**CIVIC/CONVENTION CENTER
375 South Castell Avenue
New Braunfels, TX 78130**

ADA SELF-EVALUATION FACILITY SURVEY

New Braunfels Civic/Convention Center

Jun 29, 2021

#4 Priority 1: Accessible Routes

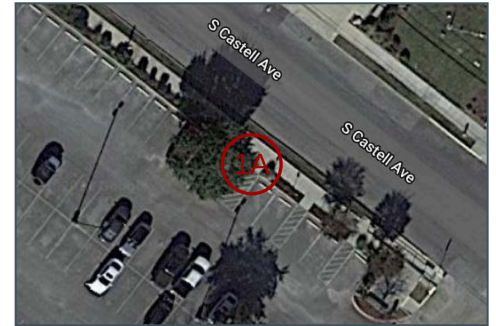
The route from the van accessible parking space to the public sidewalk has an approximate 1" wide gap.

Recommendation: Fill gap with caulking material.

#5 Priority 1: Accessible Routes

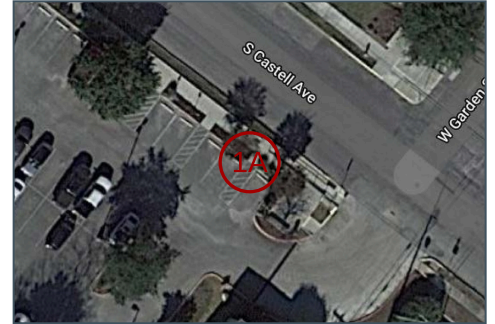
The route from the easternmost accessible parking spaces to the public sidewalk has two approximately 1" wide gaps.

Recommendation: Fill gaps with caulking material.

#6 Priority 1: Accessible Routes

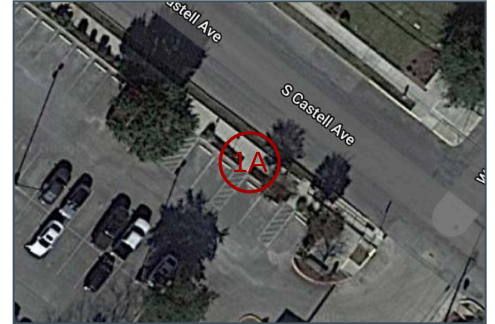
The route from the two center accessible parking spaces to the public sidewalk has two approximately 1" wide gaps.

Recommendation: Fill gaps with caulking material.

#10 Priority 1: Accessible Routes

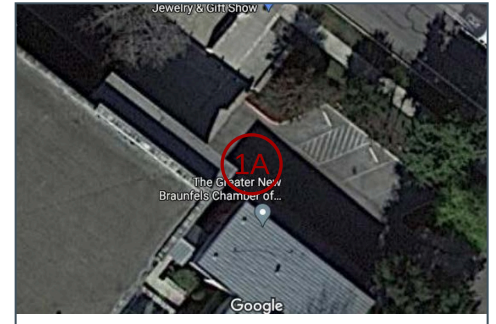
Description
The base of the curb ramp
has a change in level of
approximately 1/2".

Recommendation: Grind the
edge to create a maximum
1:2 bevel.

#8 Priority 1: Entrances

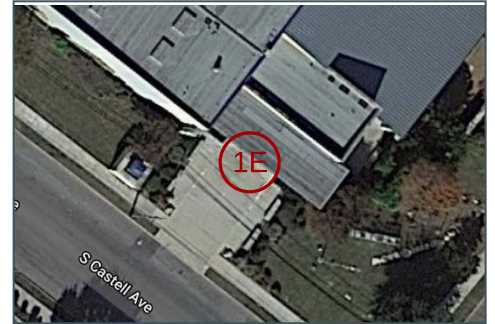
The door maneuvering area on the pull side of the entrance doors has a running slope of approximately 3.1%.

Recommendation: Replace landing area at door and stair.

#1 Priority 1: Parking

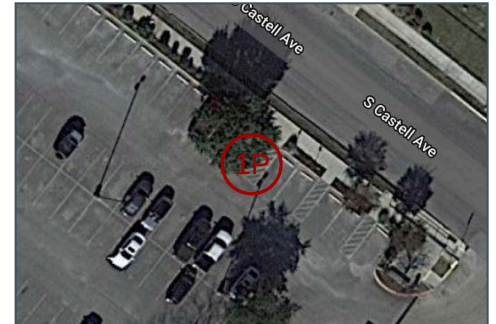
Description
The van accessible parking space and access aisle have a running slope of up to 3.3% and has some cracking and gaps in the asphalt.

Recommendation: Replace asphalt surface at parking space and access aisle.

#3 Priority 1: Parking

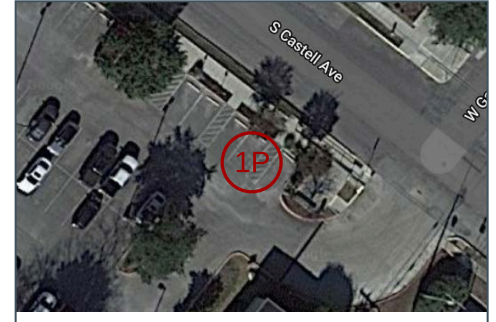
The three easternmost accessible parking spaces have cracking and gaps in the asphalt, and the easternmost accessible parking space has a running slope of up to 2.8%.

Recommendation: Replace asphalt surface at parking spaces and access aisles.

#9 Priority 1: Parking

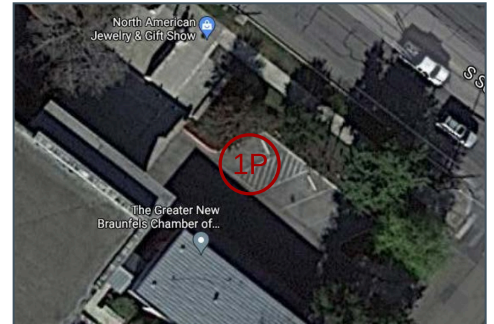
Description
Both accessible parking spaces and the shared access aisle have excessive cross slopes ranging from 3.3% to 3.9%.

Recommendation: Replace asphalt surface at parking spaces.

#7 Priority 1: Ramps

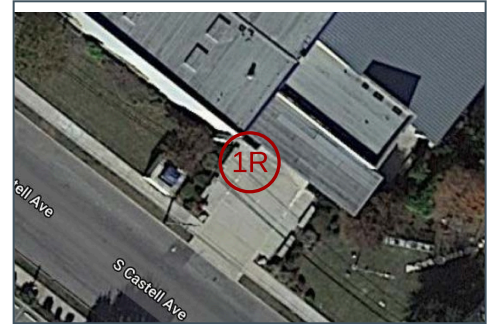
The ramp at the south entrance has the following issues:

- 1) Excessive gaps surrounding the bottom landing
- 2) Missing handrail extension on one side of the top and bottom landings
- 3) Intermediate landing is less than 60" x 60" clear
- 4) Upper landing has a cross slope of approximately 2.8%

Recommendation: Remove and replace ramp.

#18 Priority 2: Doors

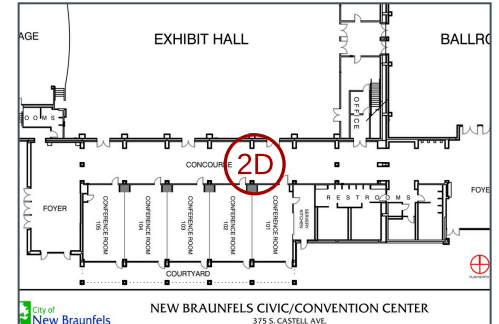
Door vision panels in the 5 conference room doors are positioned with the bottom of the glass more than 43" high.

Recommendation: Install doors with vision panels no higher than 43".

#61 Priority 2: Doors

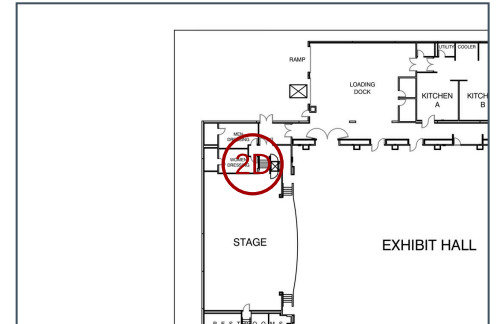
Description
The door has only 17-1/2" of clearance past the strike on the pull side.

Recommendation: Although the clearance is technically less than the allowable, this appears to be within reasonable tolerance. If this door is modified or replaced in the future, correction will be required.

#73 Priority 2: Doors

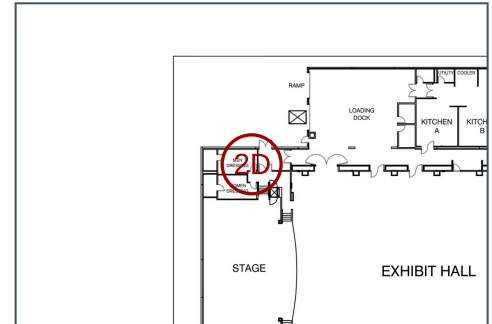
Description
The door has a 49" wide side approach on the pull side. Doors with closers require a minimum 54" side approach width.

Recommendation: Remove door closer.

#12 Priority 2: Reach Range

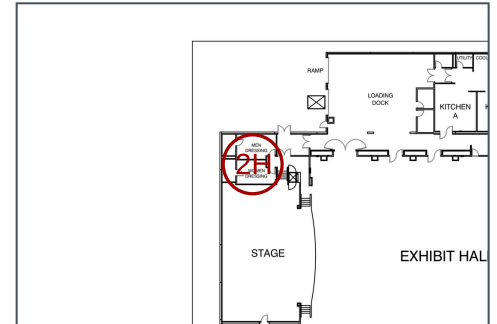
The shelf above the clothes rod is 51-1/2" high.

Recommendation: Lower a portion of rod and shelf to a maximum height of 48".

#59 Priority 2: Reach Range

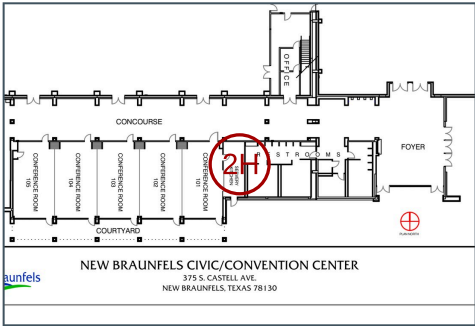
Description
The soap dispenser is positioned with the operable part 51-3/4" high.

Recommendation:
Reposition dispenser with operable parts no more than 44" high.

#60 Priority 2: Reach Range

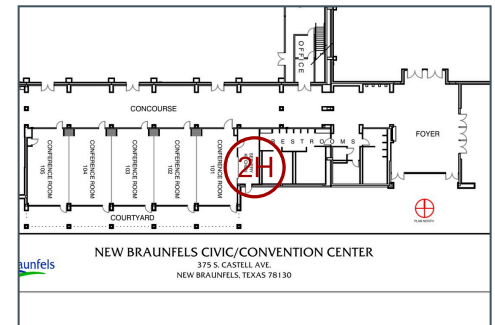
The disposal switch and convenience outlets are positioned 47-3/4" high.

Reposition the disposal switch and outlets with all operable parts and receptacles 46" high maximum.

#25 Priority 2: Sinks

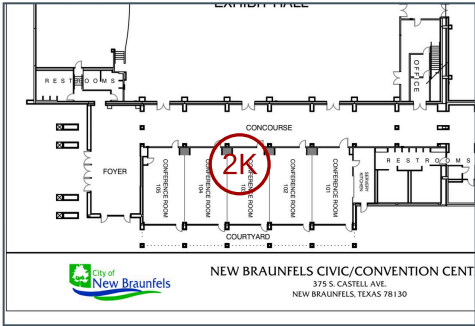
Description
The sinks in each of the 5 conference rooms have a toe space that is only 7" high.

Recommendation: Modify panel to provide a minimum 9" high toe space.

#58 Priority 2: Sinks

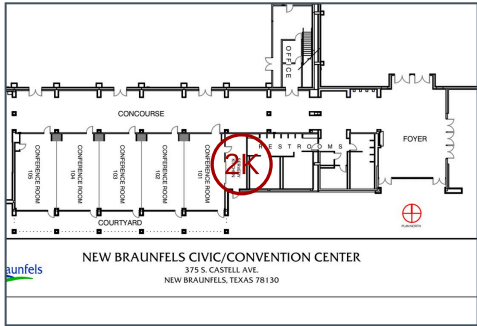
Description
The sink has a knee space height of only 25" below the sink.

Recommendation: Replace sink with a shallower model.

#14 Priority 2: Protruding Objects

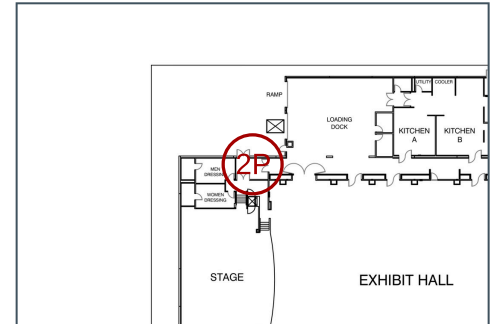
A series of panels and equipment boxes project more than 4" from the wall between 27" and 80" high.

Recommendation: Add cane detection railing below.

#15 Priority 2: Protruding Objects

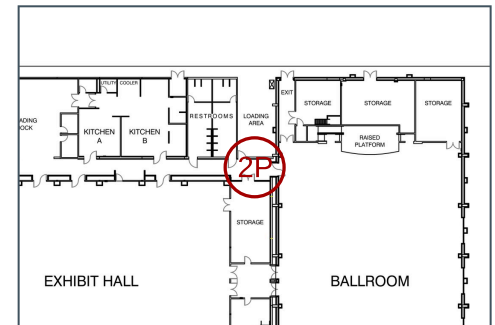
Description
The panel box near the ballroom projects more than 4" from the wall between 27" and 80" high.

Recommendation: Add cane detection railing below.

#21 Priority 2: Protruding Objects

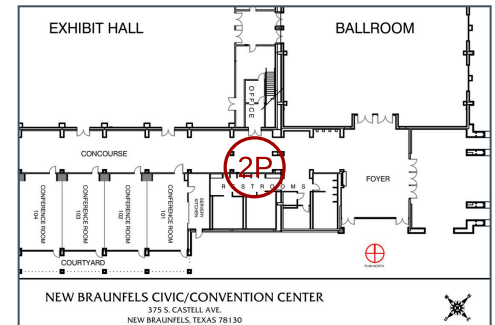
The Blood Control Kit and AED boxes project more than 4" from the wall at a height of 27" to 80" high.

Recommendation: Add cane detection element below.

#22 Priority 2: Protruding Objects

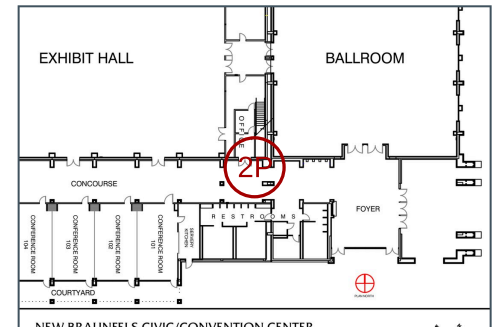
The wall-mounted TV outside of the office entrance projects more than 4" from the wall at a height of 27" to 80".

Recommendation: Add cane detection element below.

#16 Priority 2: Ramps

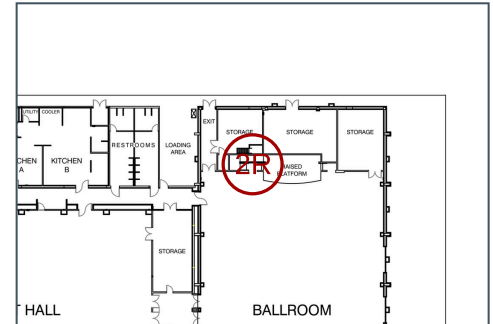
The ramp to the stage has the following noncompliant conditions:

- 1) The slope of both runs are approximately 8.5%; however, it may be considered within reasonable construction tolerance
- 2) The bottom landing has an approximate 1/2" high change in level
- 3) The intermediate landing is not 60" x 60" clear

Recommendation: Remove and replace ramp.

#29 Priority 3: Baby Changing Stations

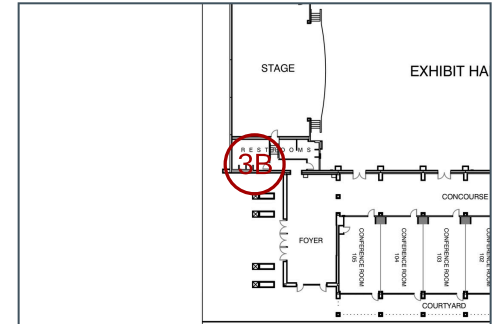
The surface of the baby changing table is 34-1/2" high in the open position. (Please note that TDLR considers baby changing stations to be protruding objects in their open position where the bottom of the table is more than 27" high. In this instance, the table obstructs the door maneuvering clearance in the open position.)

Recommendation: Relocate baby changing station outside of the door maneuvering area and position with the top of the table 28" to 34" high in the open position.

#33 Priority 3: Toilet Compartments

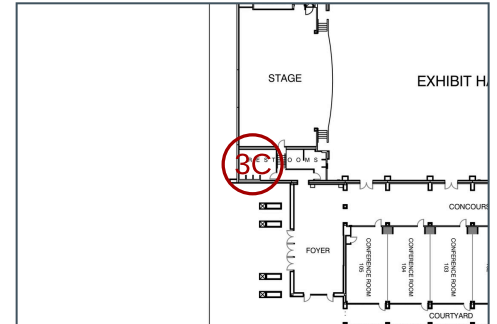
The door to the wheelchair accessible toilet stall does not have a pull on the inside.

Recommendation: Install door pull.

#37 Priority 3: Toilet Compartments

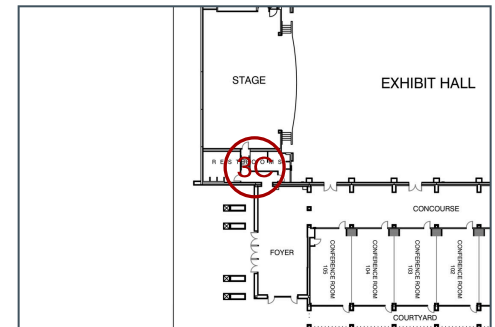
The door to the wheelchair accessible toilet stall is not self-closing.

Recommendation: Adjust door hinges.

#38 Priority 3: Toilet Compartments

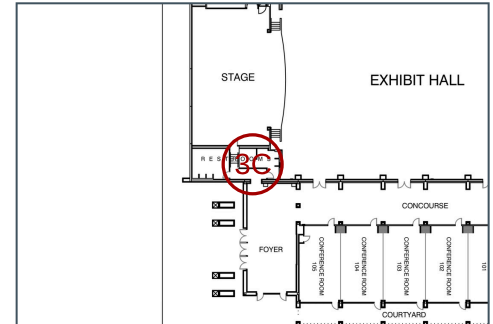
Description
The door to the wheelchair accessible toilet stall does not have a pull on the inside.

Recommendation: Install door pull.
(Note: If the stall door and hardware were installed prior to March 15, 2012, it may enjoy safe harbor until replaced.)

#43 Priority 3: Toilet Compartments

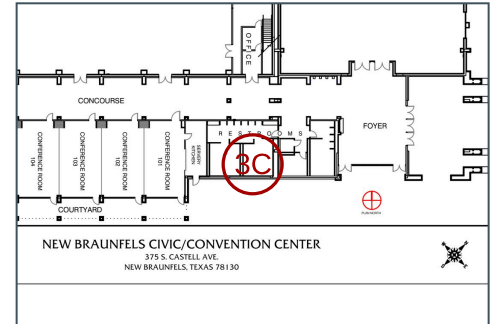
The door to the wheelchair accessible toilet stall does not have a pull on the inside.

Recommendation: Install door pull.

#44 Priority 3: Toilet Compartments

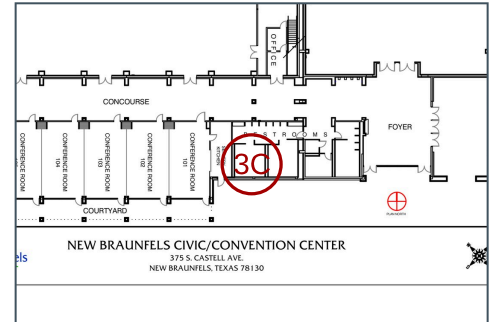
Description
The door to the ambulatory accessible toilet stall does not have a pull on the inside.

Recommendation: Install door pull.
(Note: If the stall door and hardware were installed prior to March 15, 2012, it may enjoy safe harbor until replaced.)

#45 Priority 3: Toilet Compartments

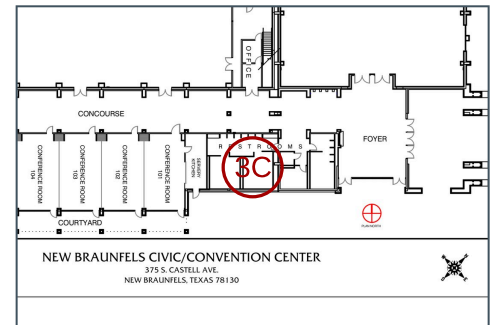
The door to the wheelchair accessible toilet stall is not self-closing.

Recommendation: Adjust door hinge.

#46 Priority 3: Toilet Compartments

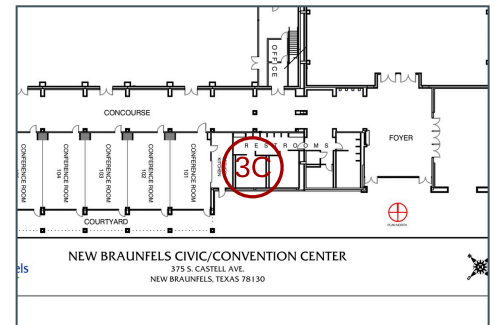
The door to the ambulatory accessible toilet stall is not self-closing.

Recommendation: Adjust door hinges.

#50 Priority 3: Toilet Compartments

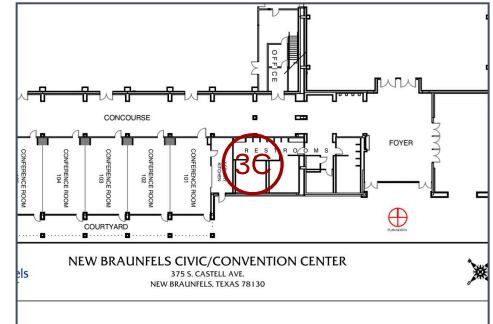
Description
The side approach width to the ambulatory accessible toilet stall is only 41" wide. A minimum 42" width is required.

Recommendation:
Reconfigure partitions to provide a minimum 42" clearance.

#54 Priority 3: Toilet Compartments

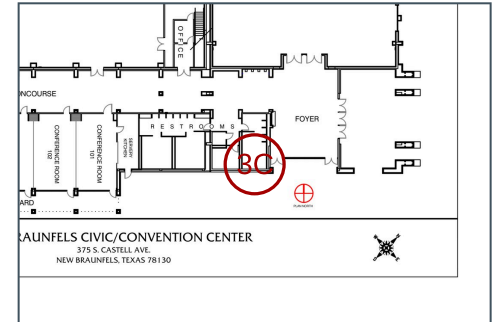
The door to the wheelchair accessible toilet stall does not have a pull on the inside.

Recommendation: Install door pull.

#55 Priority 3: Toilet Compartments

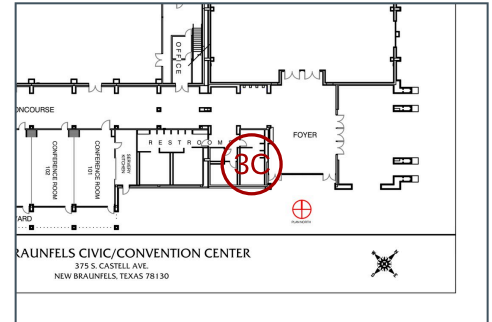
Description
The door to the ambulatory accessible toilet stall does not have a pull on the inside.

Recommendation: Install door pull.
(Note: If the stall door and hardware were installed prior to March 15, 2012, it may enjoy safe harbor until replaced.)

#56 Priority 3: Toilet Compartments

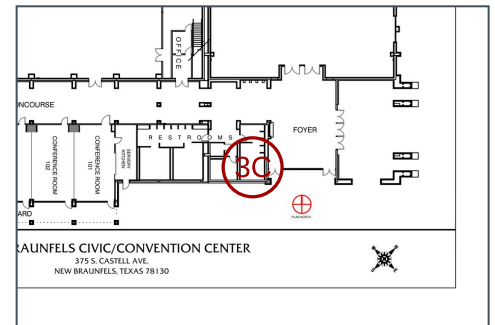
The door to the wheelchair accessible toilet stall is not self-closing.

Recommendation: Adjust door hinges.

#57 Priority 3: Toilet Compartments

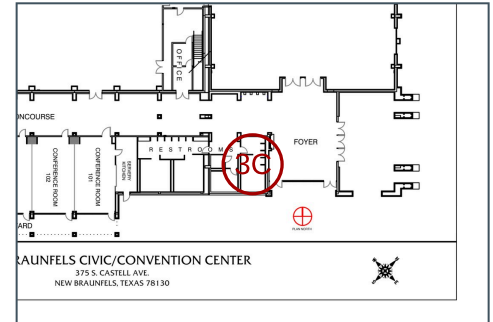
The door to the ambulatory accessible toilet stall is not self-closing.

Recommendation: Adjusts door hinges.

#19 Priority 3: Doors

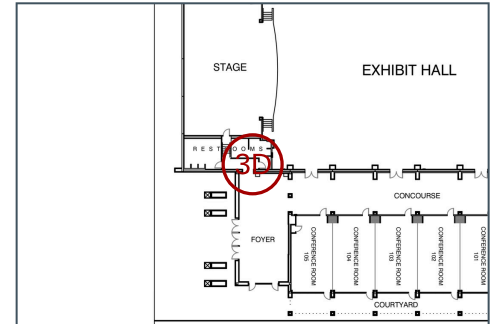
The entrance door requires more than 5 lbs of force to open.

Recommendation: Adjust door closer.

#20 Priority 3: Doors

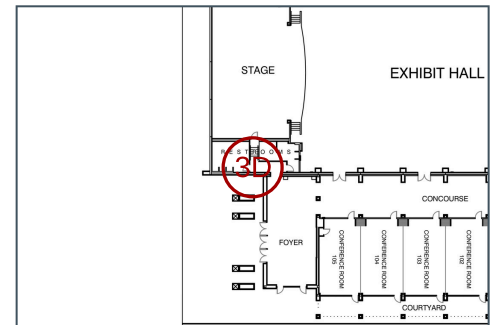
The entrance door requires more than 5 lbs of force to open.

Recommendation: Adjust door closer.

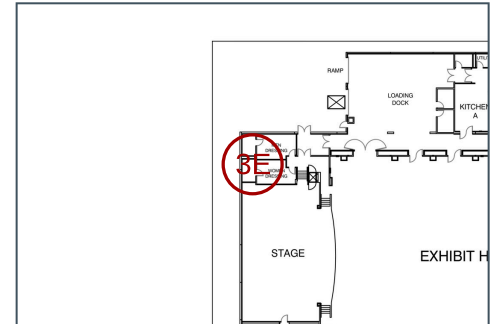
The bench does not have a clear floor space at the end for a side transfer.

Recommendation: Install an accessible bench with a 30x48 clear floor space at the end for side transfer.
(Note: If the bench was installed prior to March 15, 2012, it may enjoy safe harbor until modified or replaced.)

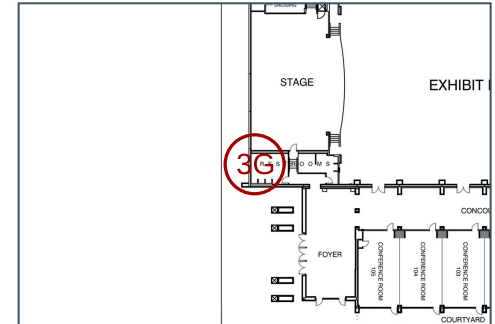
The grab bars in the wheelchair accessible toilet stall are positioned with the top of the bar 36-1/2" high. The side grab bar has a clearance of less than 12" between the bar and the toilet paper dispenser

Reposition grab bars 33" to 36" to the top of the gripping surface with a minimum 12" clearance above and 1 1/2" below. See related Item #32. (Note: If the grab bars and dispenser were installed prior to March 15, 2012, they may enjoy safe harbor until modified or replaced.)

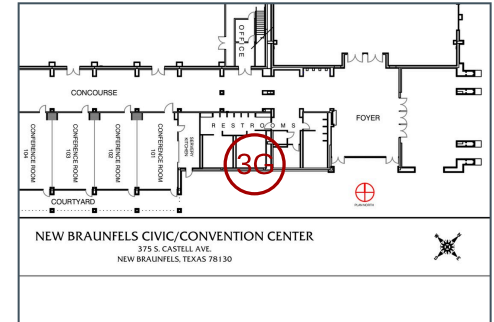
The grab bars in the wheelchair accessible toilet stall are positioned with the top of the bar 36-3/4" high. The side grab bar has a clearance of less than 12" between the bar and the toilet paper dispenser.

Reposition grab bars 33" to 36" to the top of the gripping surface with a minimum 12" clearance above and 1 1/2" below. See related Item #48. (Note: If the grab bars and dispenser were installed prior to March 15, 2012, they may enjoy safe harbor until modified or replaced.)

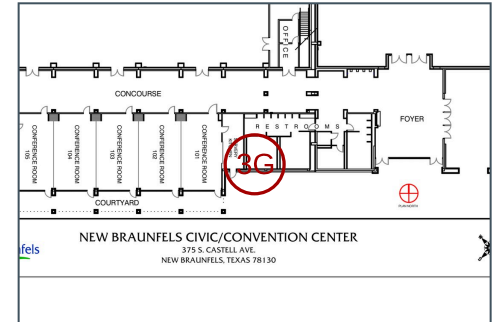
The grab bars in the ambulatory accessible toilet stall are positioned 13" from the rear wall and with the top of the bar 36-3/4" high. The side grab bar has a clearance of less than 12" between the bar and the toilet paper dispenser.

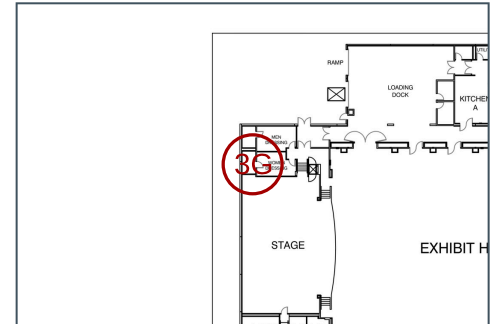
The grab bars at the water closet are positioned with the top of the bar 36-1/2" high. The side grab bar has a clearance of less than 12" between the bar and the toilet paper dispenser

Recommendation: Position grab bars 33" to 36" to the top of the gripping surface with a minimum 12" clearance above and 1 1/2" below.

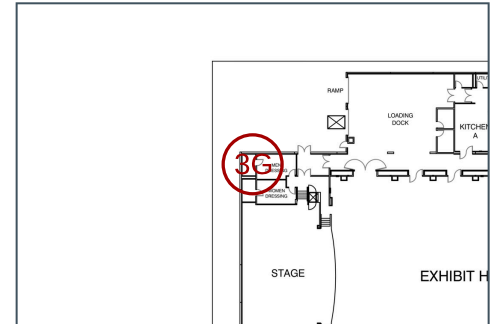
The grab bars at the water closet are positioned with the top of the bar 36-1/2" high. The side grab bar has a clearance of less than 12" between the bar and the toilet paper dispenser

Reposition grab bars 33" to 36" to the top of the gripping surface with a minimum 12" clearance above and 1 1/2" below.

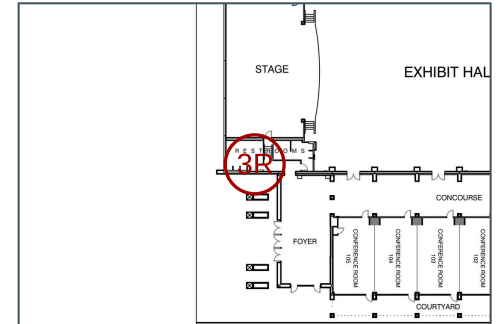
The openings of both paper towel dispensers are 50" and 49 1/2" high.

Reposition at least one dispenser with opening no higher than 48".

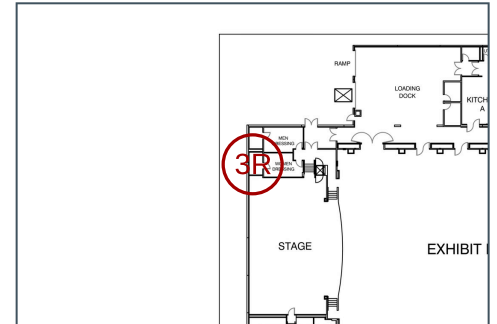
The opening of the paper
towel dispenser is 50" high.

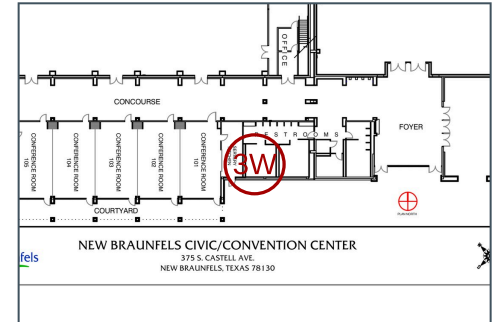
The toilet paper dispenser in the ambulatory accessible toilet stall is not centered 7 to 9" in front of the water closet.

Reposition the dispenser below the grab bar with the centerline 7" to 9" in front of the water closet. See related Item #51.

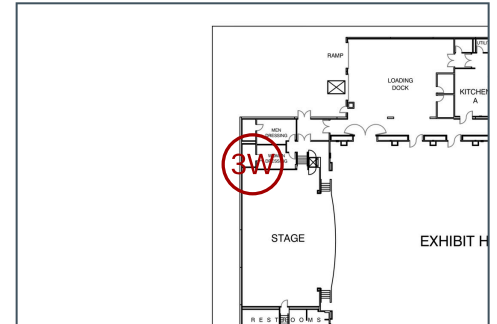
The water closet is centered approximately 18-1/4" from the side wall.

Reposition the water closet with the centerline 16" to 18" from side wall. (Note: If the water closet was installed prior to March 15, 2012, it may enjoy safe harbor until modified or replaced.)
